AMENDMENTS TO THE DRAWINGS:

REMARKS

FIG. 5

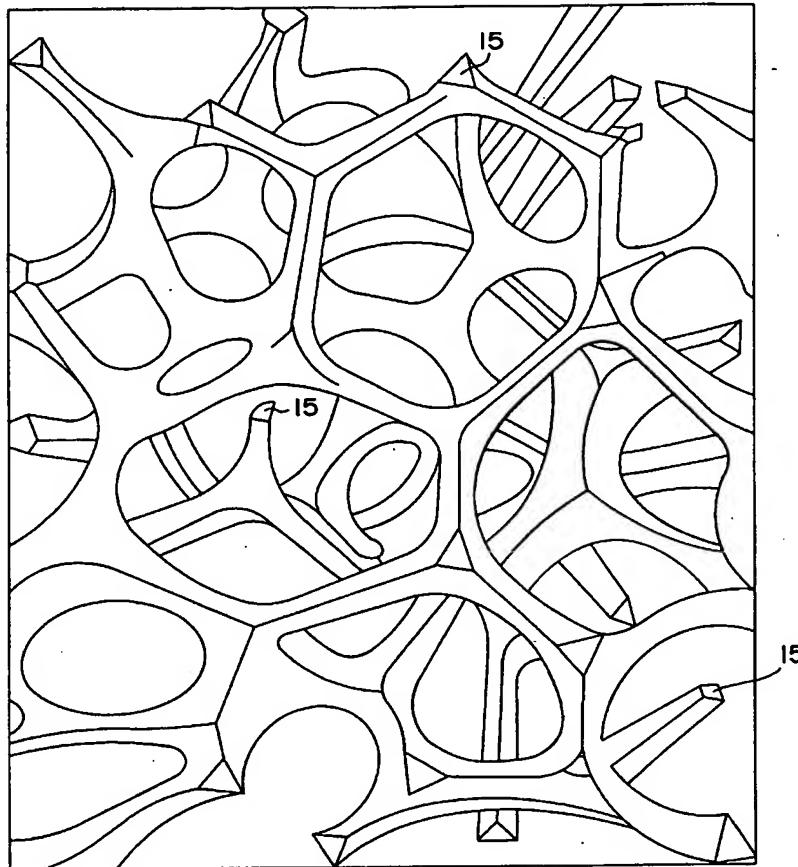
- to clearly identify element [108] in Fig. 5b;
- to add label "Fig. 6" to that figure;
- to clearly identify element [222] in Fig. 9a and 9b;
- to clearly identify element [225] in Fig. 12a.

Claim 1, as amended, recites “said anodic chamber (1) and said cathodic chamber (10) each has an electrically conductive reticulated element (7, 206).” Jones fails to teach at least this element. The electrically conductive material in the fuel cell in Jones is the fluid flow plate 120. See Jones, Fig. 2-4 and col. 5, lines 32-45. In particular, Jones describes that “flow channels are typically formed on the face of the fluid flow plate by machining,” and that “the flow channels [in the fluid flow plate] carry an appropriate reactant fluid.” *Id.* at col. 5, lines 34-43. In contrast, the reticulated metallic element is described in the present specification as “electrically connecting the conductive bipolar plates 3 to the porous electrode 5 while simultaneously distributing the gaseous reactants.” See Specification at 6, lines 2-5. As an example, the specification makes reference to reticulated materials “of the type described in U.S. Pat. No. 5,482,792.” See specification at 6, lines 2-4. U.S. Pat. No. 5,842,792, in turn, describes a reticulated material as a tridimensional network of metal veins or wires. See Fig. 5 below.
